Docket Item # 3  
BAR CASE # 2013-00017

BAR Meeting  
February 20, 2013

**ISSUE:** Certificate of Appropriateness  
**APPLICANT:** Bank of America c/o CBRE  
**LOCATION:** 110 South Union Street  
**ZONE:** CD/Commercial Downtown Zone

The applicant requests approval of a Certificate of Appropriateness at 110 South Union Street for alterations to the west elevation of the building to install an ATM. The applicant proposes to remove an existing door and replace it with an ATM in a monochrome gray color and one acrylic plastic wall sign with the Bank of America logo and name. The remaining area of the former door opening will be filled with new insulated wood panel to match the paneling beneath the building's bay window. In addition, the applicant also requests approval to apply a new opaque film on an existing window on the north elevation and to install a CCTV camera on an existing clearance beam. The applicant intends to install a new HVAC unit, at ground level, with screening, on the north side of the building.

**1 BofA ATM Layout**  
SK.1 SCALE: 1/8" = 1'-0"

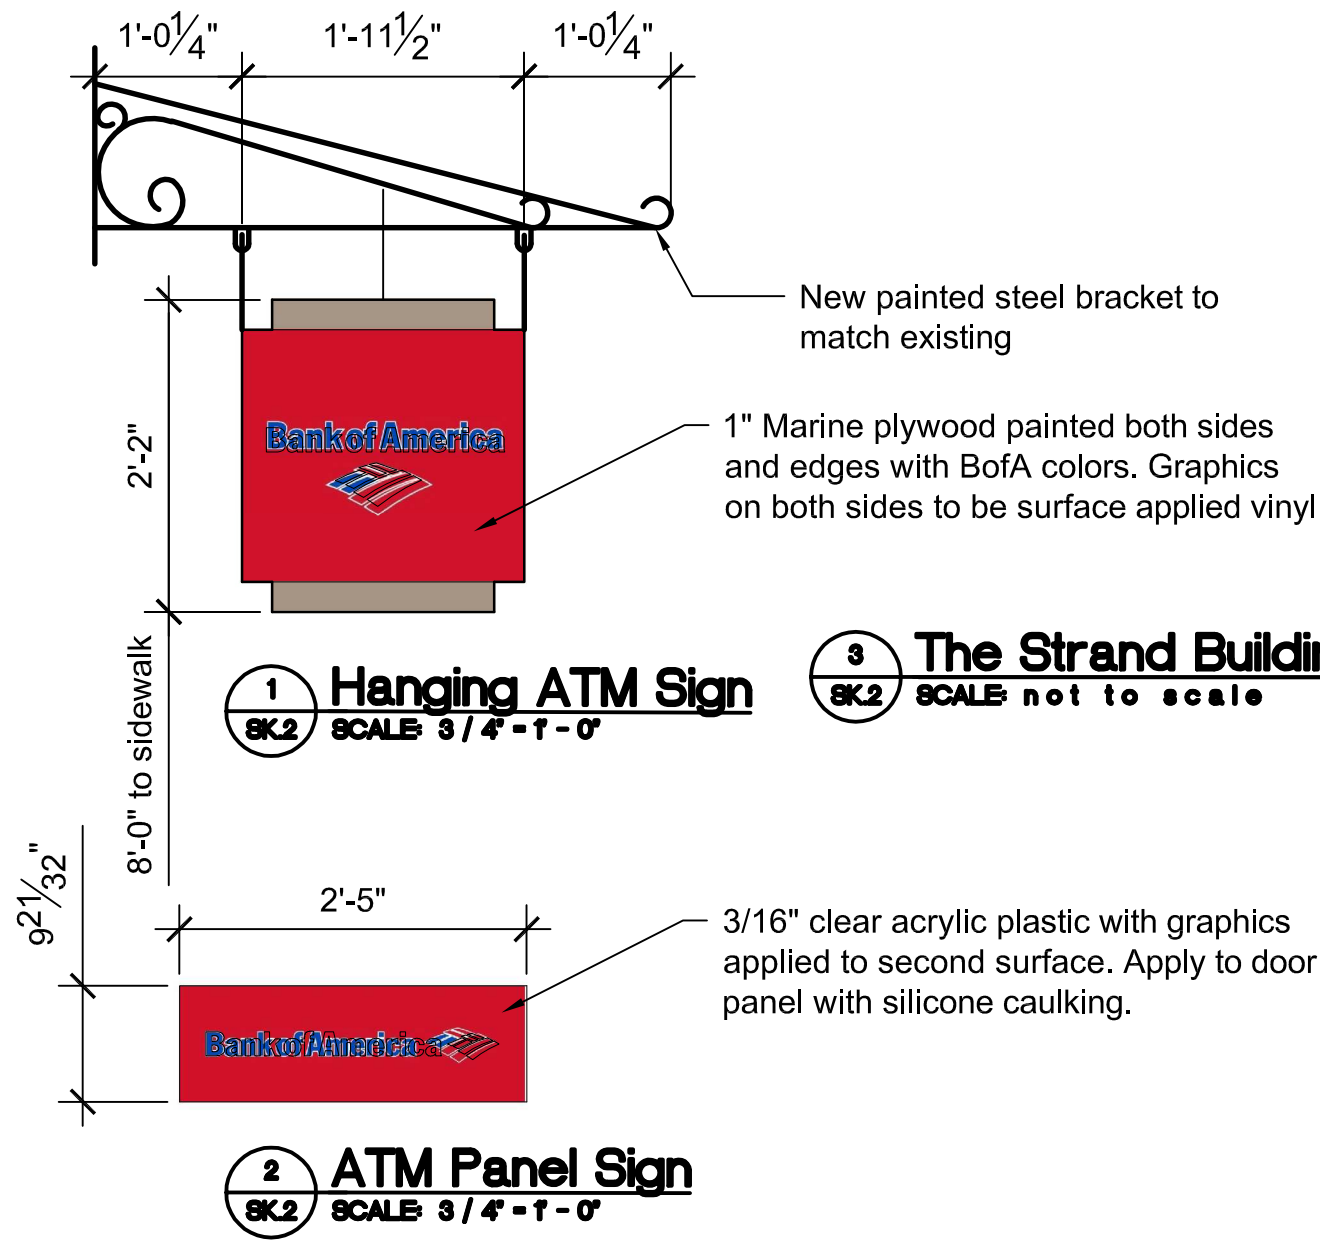
***The applicant has not submitted a lighting plan. The applicant intends to replace the bulbs in the existing light fixtures. Any replacement bulbs must meet the above requirement. Staff notes that there is an existing street light in front of the proposed ATM. As proposed, the lighting may exceed this requirement.***

1. Elimination of the hanging sign, per section 7-1800 of the Zoning Ordinance, and
2. Lighting elements shall be the minimum possible to meet safety requirements, and shall not exceed 2.0 foot candles measured at a radius of five feet from the source.

**1 Hanging ATM Sign**  
 SK2 SCALE: 3/4" = 1'-0"

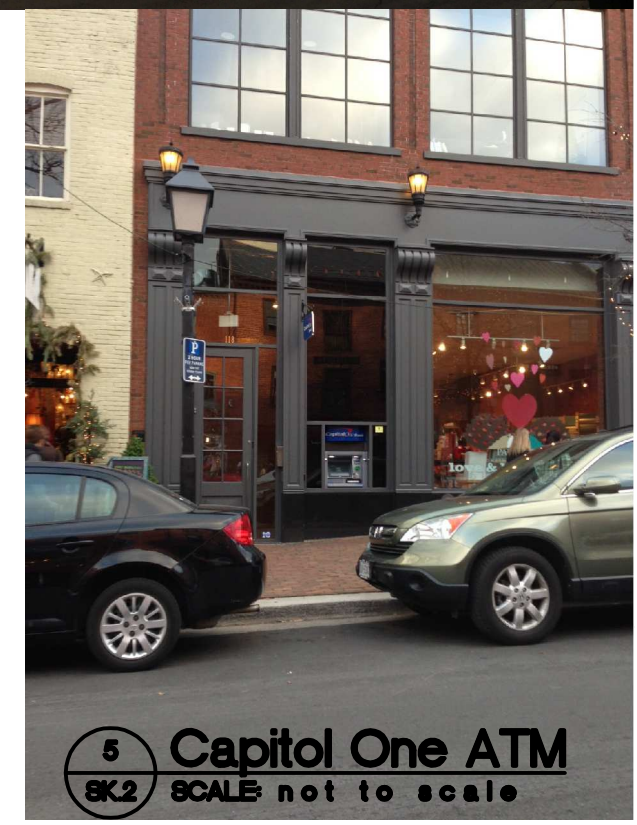
***The proposed sign is located at the top of the machine. The width of the sign is equal to the width of the machine (2.42 feet). The height of the proposed sign is 9 5/8", which equals 0.32 of the machine's height and is one-third (0.33) the width of the machine. The sign is not backlit. The proposed hanging sign does not comply.***

Staff believes that the proposed ATM complies with zoning requirements, with the exception of the hanging sign and lighting, and is a relatively minor and easily reversible alteration in this late 20<sup>th</sup> century building. Staff, therefore, recommends approval of the application, as conditioned.
